**6633B-08**

# S E R V I C E N O T E

## Agilent 6633B DC Power Supply

**On faster computers, when programming over GPIB, a random error will occur.**

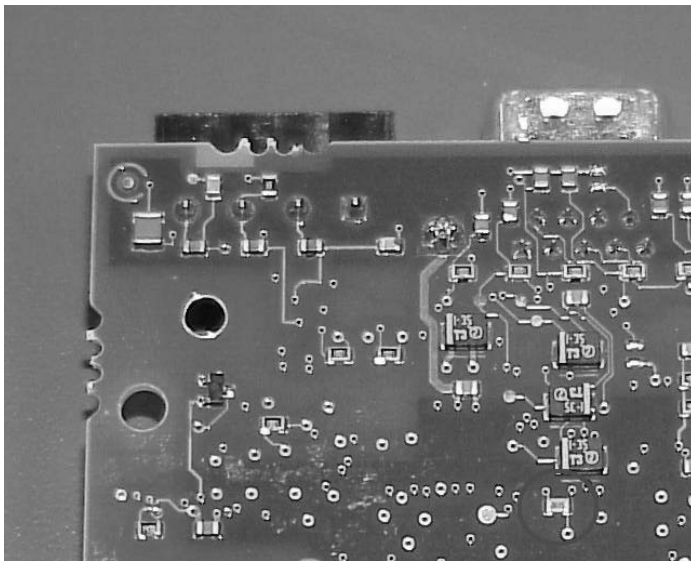
When programming a unit over GPIB, a random error -113 (“Undefined header”) will appear on the unit. This error can be read back via the front panel or over the GPIB bus.

Change resistor R1246 (see picture for location) from 511 Ohms to 100 Ohms (part number 0699-3058). This requires un-soldering and soldering a surface mount component and can be very difficult. This does not require re-calibration.

Replace the entire GPIB assembly (part number 5063-4841) with a newer one that has the 100 Ohm resistor. This will require the unit to be re-calibrated.
